CITY OF ALBUQUERQUE

RE: **Country Club Plaza** - 1720 Central Avenue SW
Grading and Drainage Plan for Site Plan, Building Permit and Work Order
File: **J13-D010**
PE Stamp: **3-18-2014**

RE: **Country Club Plaza** - 1720 Central Avenue SW
Grading and Drainage Plan for Building Permit

**Re: Country Club Plaza, Grading and Drainage Plan
Engineer's Stamp Date 10/23/13 (J13/D010)**

revision	
by	
date	
rev	◀◀◀◀◀
job number	12-11
drawn by	SJ.MWS
project manager	Doug Heller, AIA
date	11/13/12
project title	Country Club Plaza SWC of Central Avenue and Laguna Boulevard Albuquerque, New Mexico 87102
sheet title	GRADING & DRAINAGE PLAN
sheet

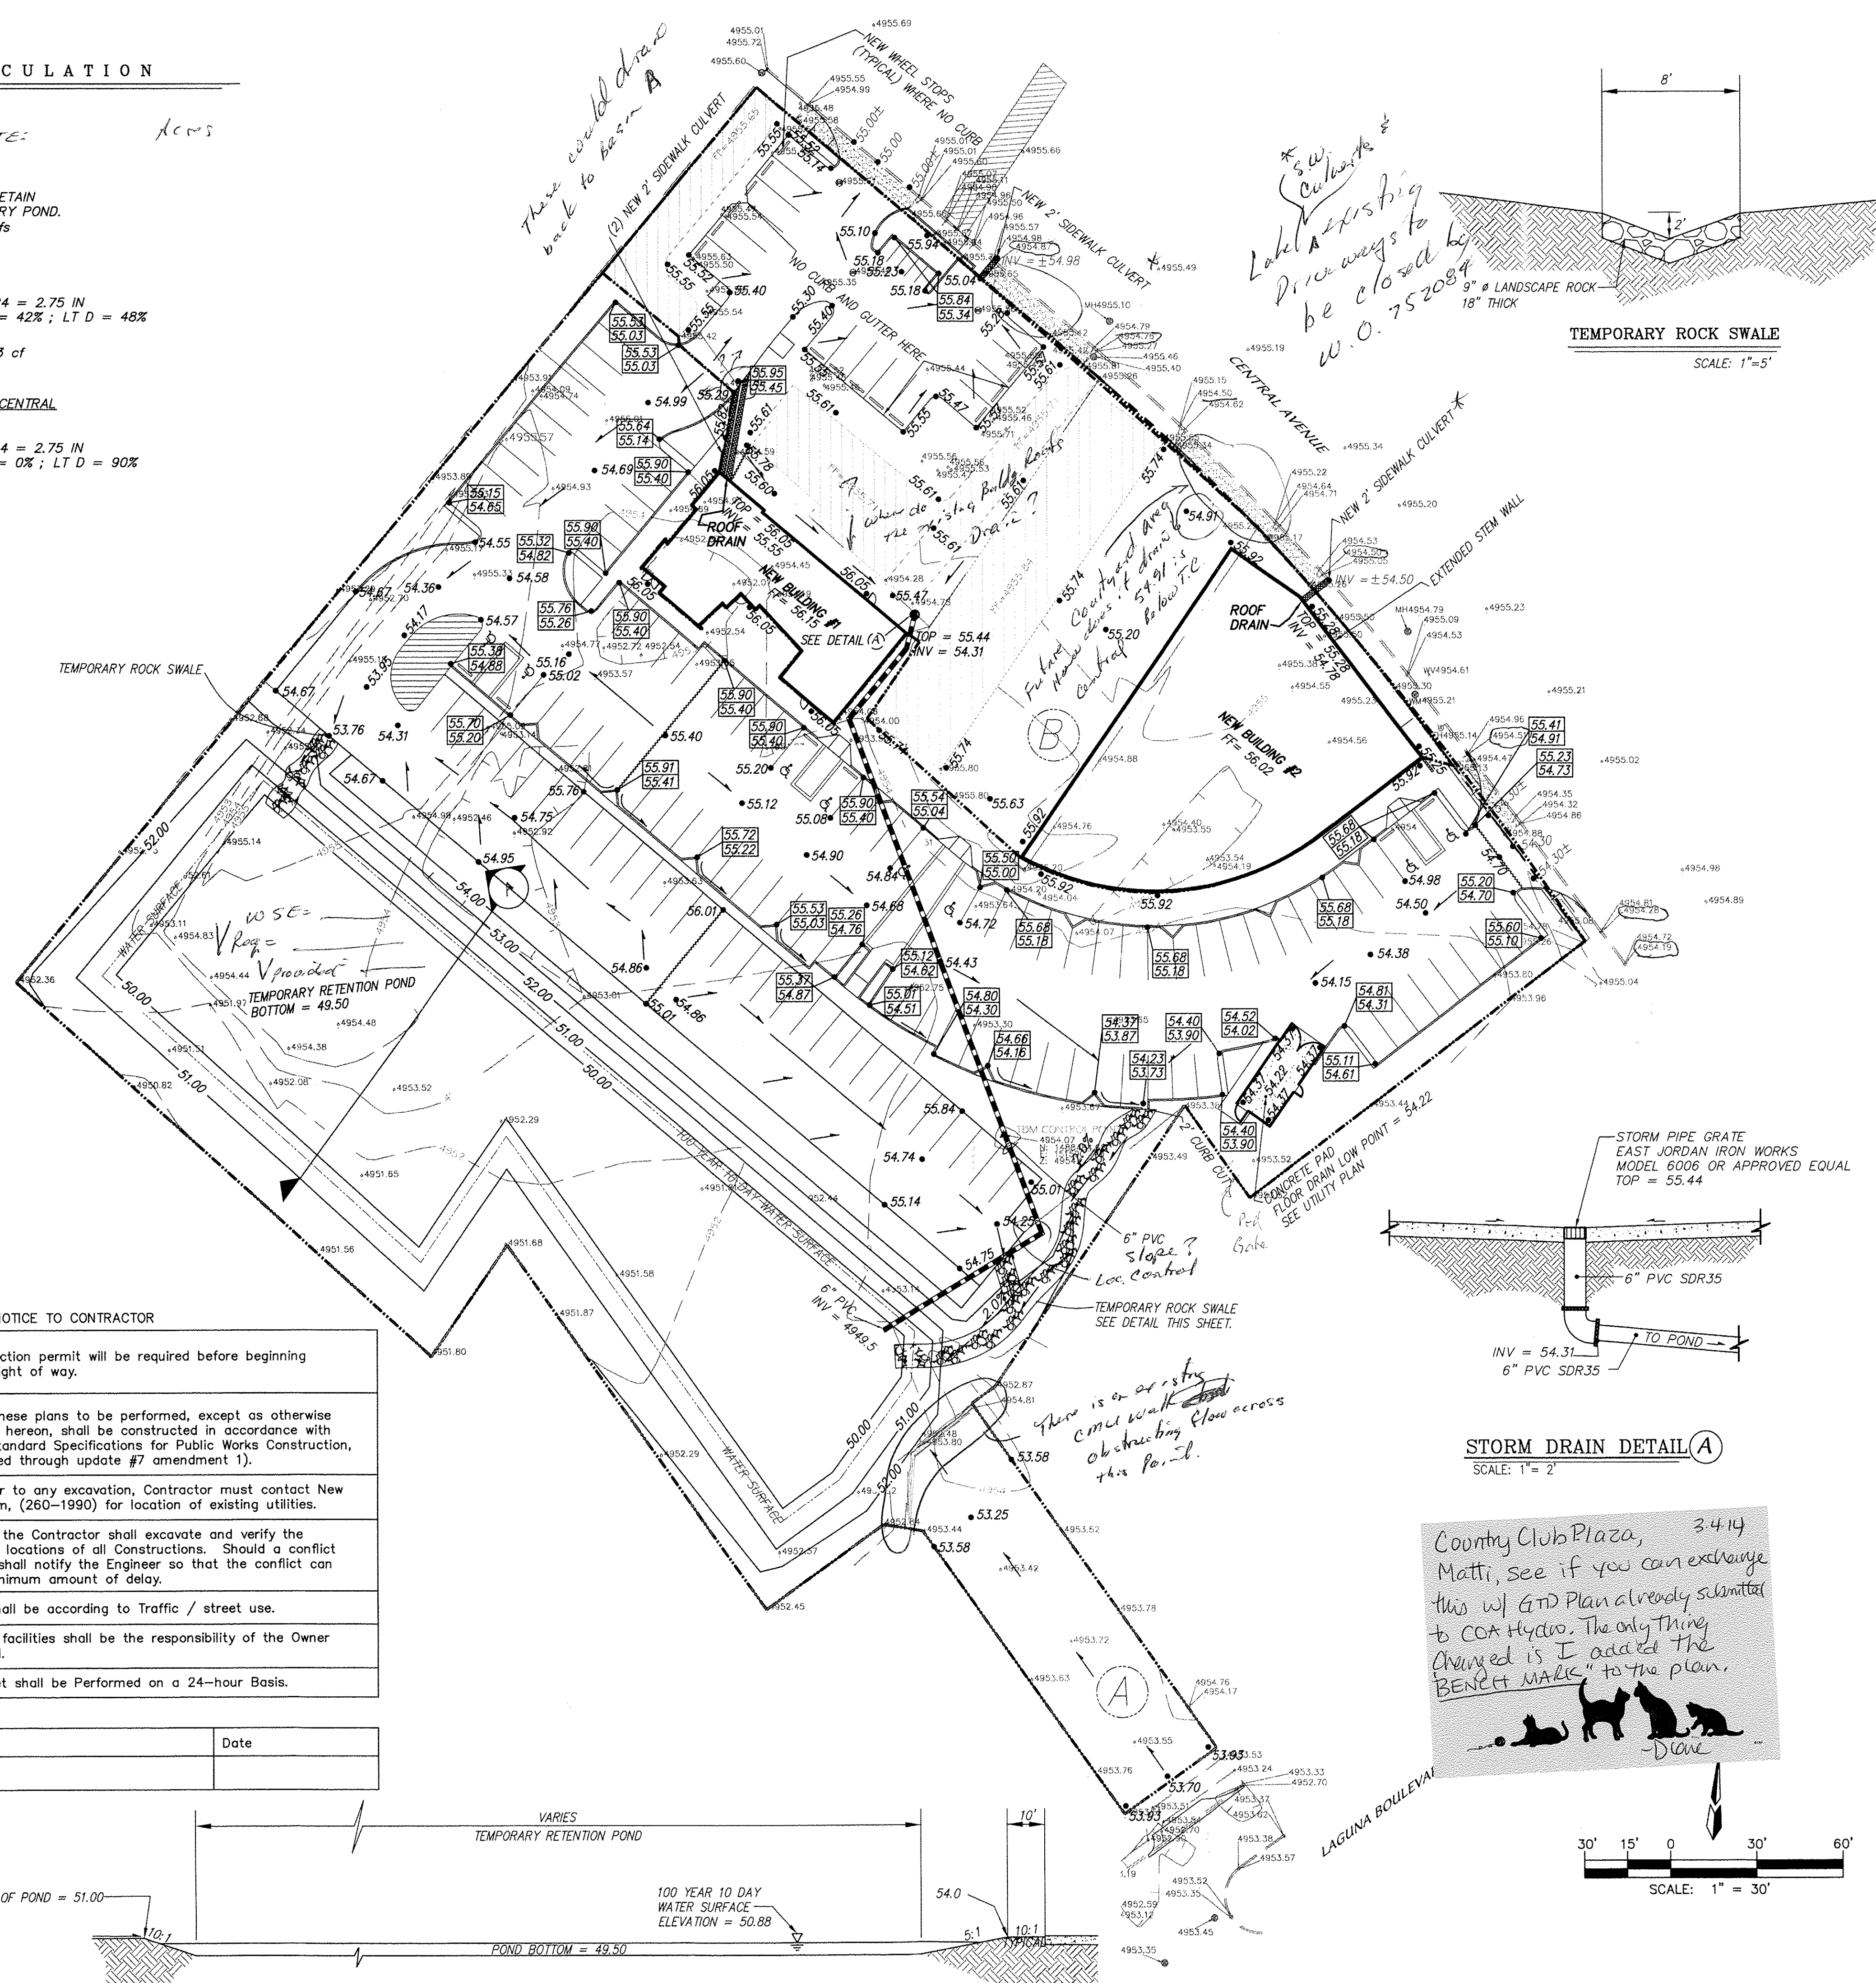
1. Show where the existing building roof drains enter the basins?
2. Show how the courtyard between the existing service station building and Future Bldg #2 drain to Central. Spot elevations appear to be below top of curb grades.

3. Show on this plan the driveways to remain open and which are to be closed by Work Order (cpn-752084?). Driveways may be outfall points for drainage.

4. The area between the existing buildings appears to drain to the dashed line that runs to the south pond. If so that's in Basin B and draining to Basin A, rather than B to Central. Does the pond volume accommodate that runoff?

5. Clearly label the dashed line (6" PVC Drain to pond) with grades and bend locations.
6. The sidewalk culverts proposed for the Bldg #1 roof runoff appear to discharge at the high point on the drive lane, and could potentially drain back south to Basin A. Provide more detail to ensure flows go to Central.

7. There is an existing CMU wall crossing the portion of the site that leads to Laguna? Show how runoff will get through it to the pond.
8. On the calculations table, include a value for the site acreage used to establish the allowable Q.

9. Label the Retention Pond with WSE, Volume Required, and Volume Provided. Confirmation of these features will be required as part of the Certification for CO.

1. It appears the grades shown on the plan may be in the 29 datum. Please check this and provide the benchmark with your next submittal.
2. It appears that Building #1 and the area between this building and the building to the north will drain to the retention pond (51.30 vs 52.30) and therefore should be included in Basin A.

3. It appears there is a high point at 4951.12 in the narrow section of the lot near Laguna Blvd which shows an existing basin (Bain C?) that drains to Laguna Blvd.

4. Building #2 should not drain over the sidewalk, a sidewalk culvert or pipe penetration through the curb should be proposed for this drainage.
5. The submittal should request an SO-19 Permit for the sidewalk culvert near the west drive pad and the solution for Building #2.

6. Should the low point 48.72 upstream of the rock swale on the east side be picked up a little to 49.5 or so?
7. Provide proposed grades in the rock swale along the eastern boundary. Existing grades in this area are higher than the upstream curb cut grade.

8. Will the flows discussed in #6 above leave the parking lot through a curb cut? How long should it be?
9. Is curbing proposed on the southern parking lot?

10. It appears there is a speed table midway in the parking lot, because curbing is shown. How will flows drain through this area?
11. Provide the volume required and volume proposed for the pond.

12. Provide calculations for flow and volume, a narrative and flood plain information.
